**CASE NO. FP-2025-0013
ORDER OF CONDITIONAL
APPROVAL OF FINAL PLAT**

DATE: 3/17/2026
TO: City Council
FROM: Sonya Allen, Associate Planner
208-884-5533
sallen@meridiancity.org
SUBJECT: FP-2025-0013
Burnside Ridge Estates No. 1

Final plat consisting of 52 buildable lots and 15 common/other lots on 26.26 acres of land in the R-4 and R-8 zoning districts for the first phase of Burnside Ridge Subdivision.

B. Final Plat (dated: 1/29/26)

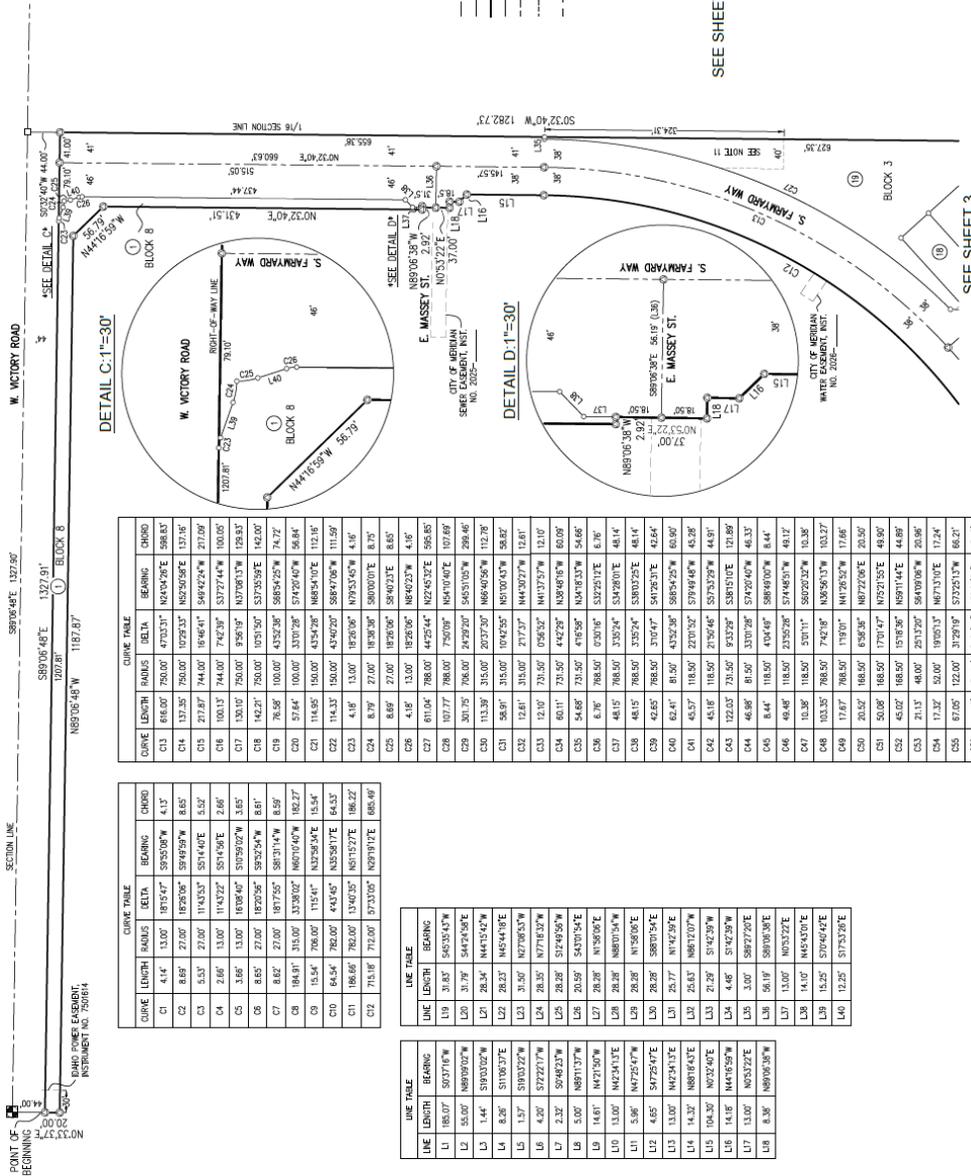
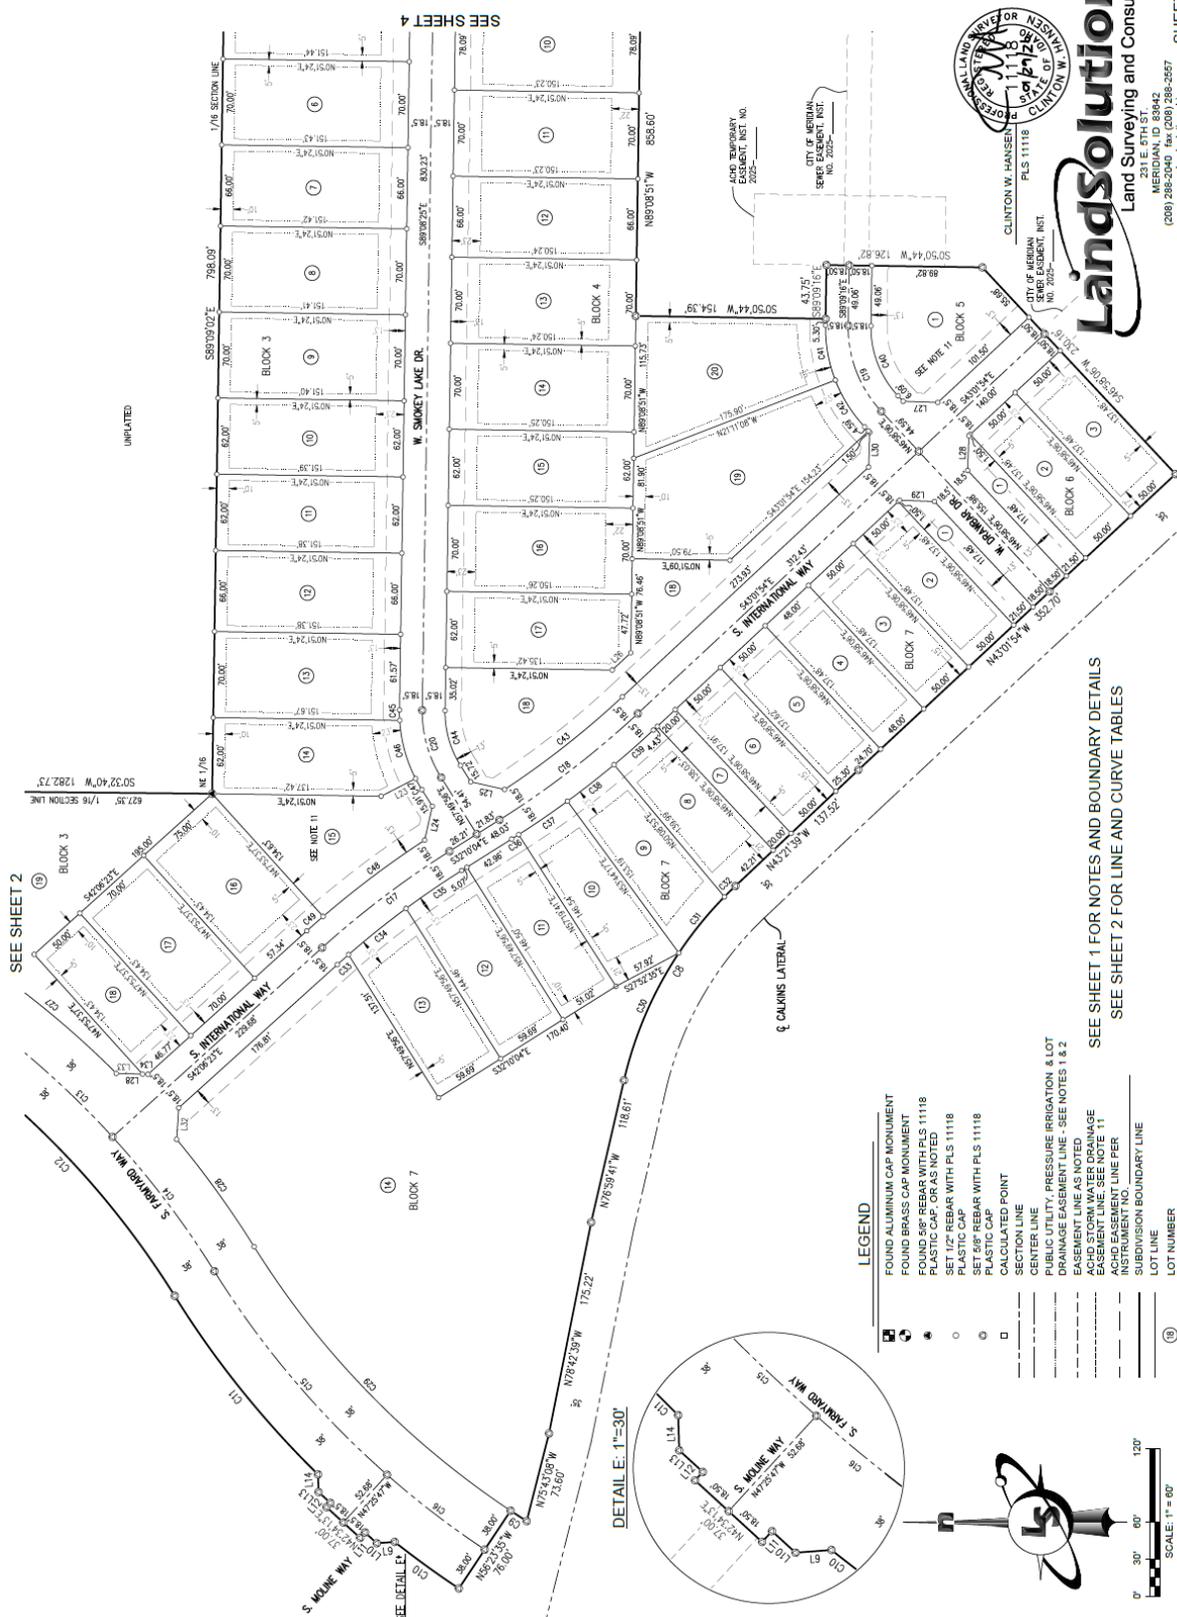
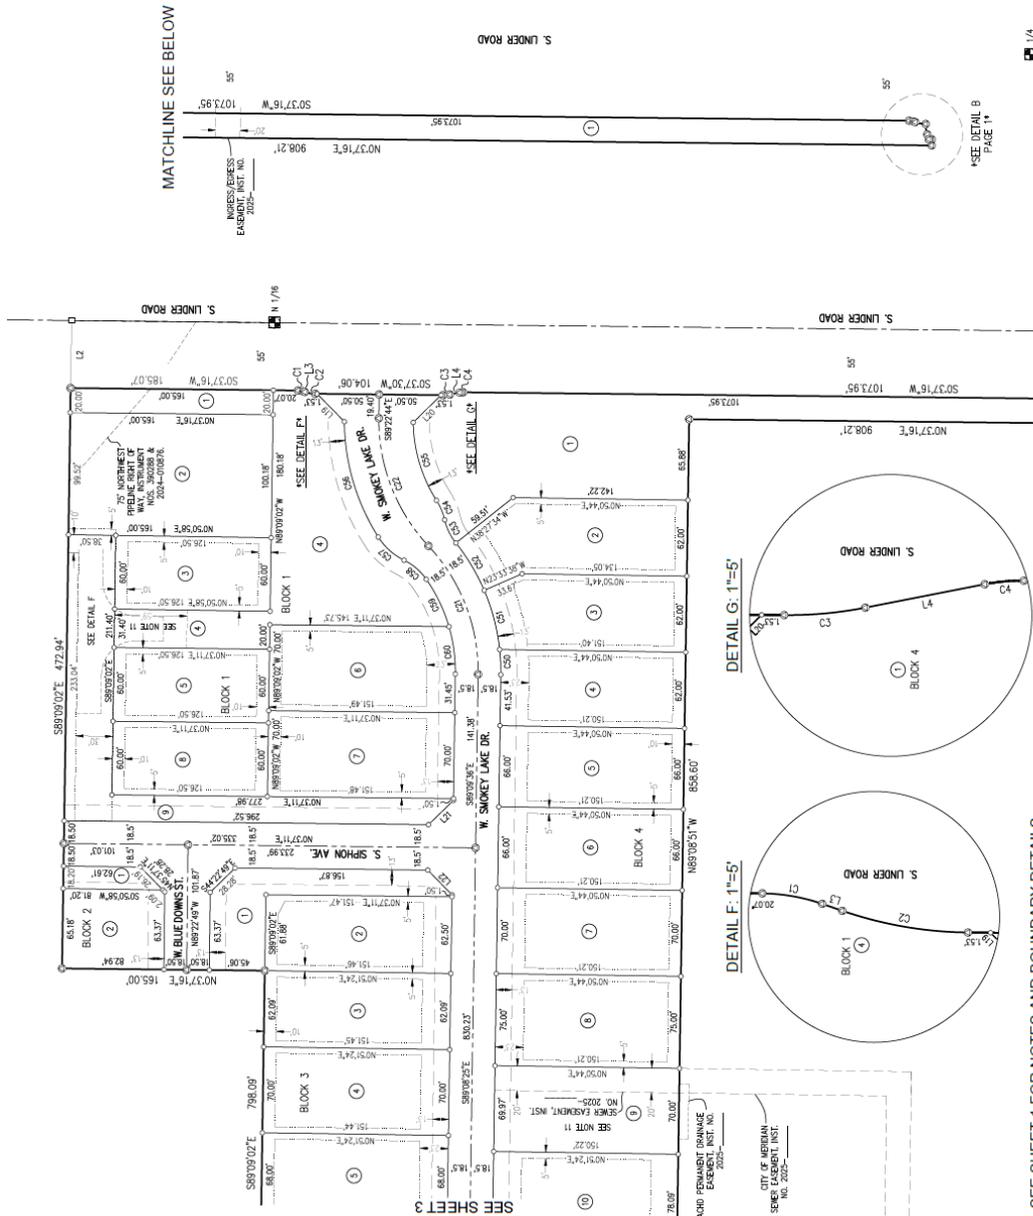
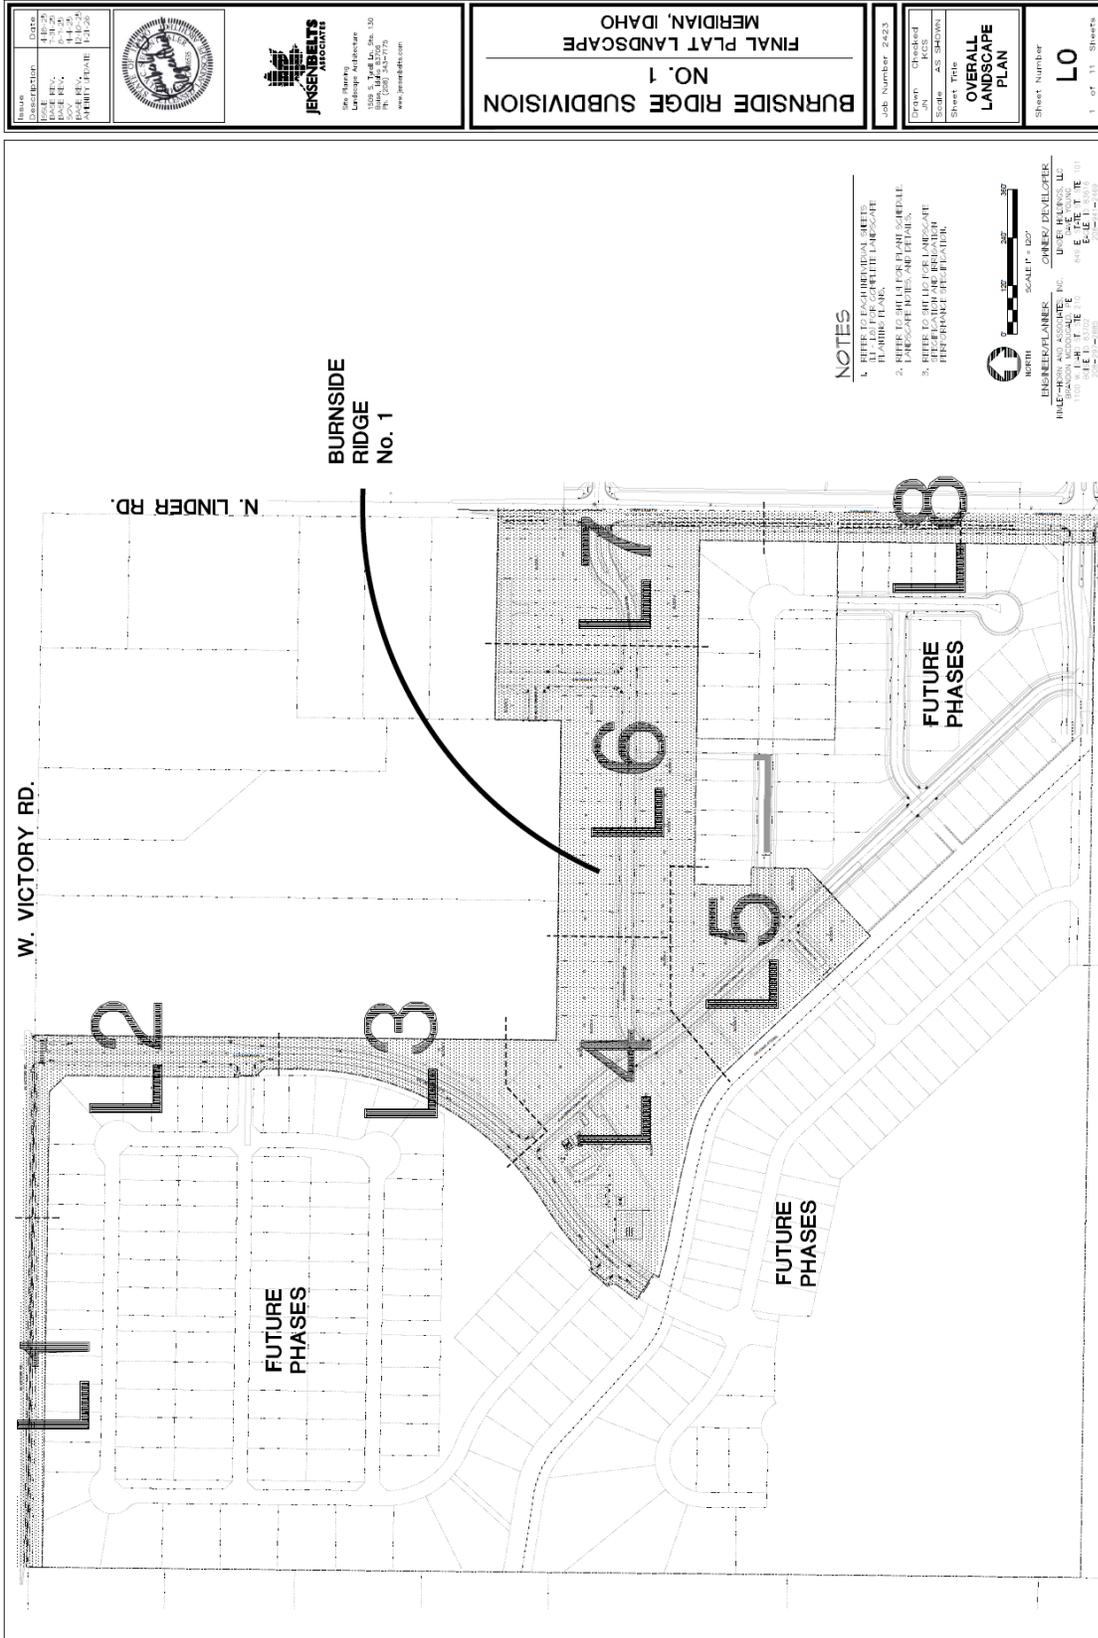
3. Prior to submittal for the City Engineer's signature, have the Certificate of Owners and the accompanying acknowledgement signed and notarized.
4. The final plat prepared by Land Solutions Land Surveying and Consulting, stamped on 8/21/25 by Clinton W. Hansen, included in Exhibit B shall be revised as follows:

- a. Note #10: Include the recorded instrument number of the development agreement (i.e. #2024-063338).
 - b. Note #12: Include the recorded instrument number of the ACHD temporary license agreement.

- c. Note #16: Include the recorded instrument of the ACHD development agreement.
 - d. Legend: Include the recorded instrument number of the ACHD permanent easement line.

- e. Include the recorded instrument number of the ACHD temporary easement graphically depicted on Sheets 3 and 4.
 - f. Include the recorded instrument number of the City of Meridian sewer easement graphically depicted on Sheets 3 and 4.

- g. Include the recorded instrument number of the ingress/egress easement graphically depicted on Sheet 4.
 - h. The final construction drawings shall depict a 10-foot-wide detached sidewalk along the northern portion of the east side of S. Farmyard Way, a collector street, in accord with preliminary plat condition #2g, unless otherwise approved through a development agreement modification. *If a modification to the DA isn't approved to reduce the width of the sidewalk to 5 feet, alternative compliance may be requested to provide an attached 10-foot-wide sidewalk.*

- i. Extend S. Siphon Ave. as a stub street to the north property boundary for future extension along with the sidewalks on either side (there appears to be a gap).

- j. Break up Lot 9, Block 1 into two (2) lots – one for the street buffer and one for the common driveway.
 - k. Depict traffic calming measures on the construction drawings for W. Smokey Lake Dr. (shown as E. Pivot Dr. on the preliminary plat) in the form of bulb-outs, chokers, stamped concrete, etc. due to the long block face; work with ACHD to determine an appropriate means of traffic calming in accord with preliminary plat condition #2e.
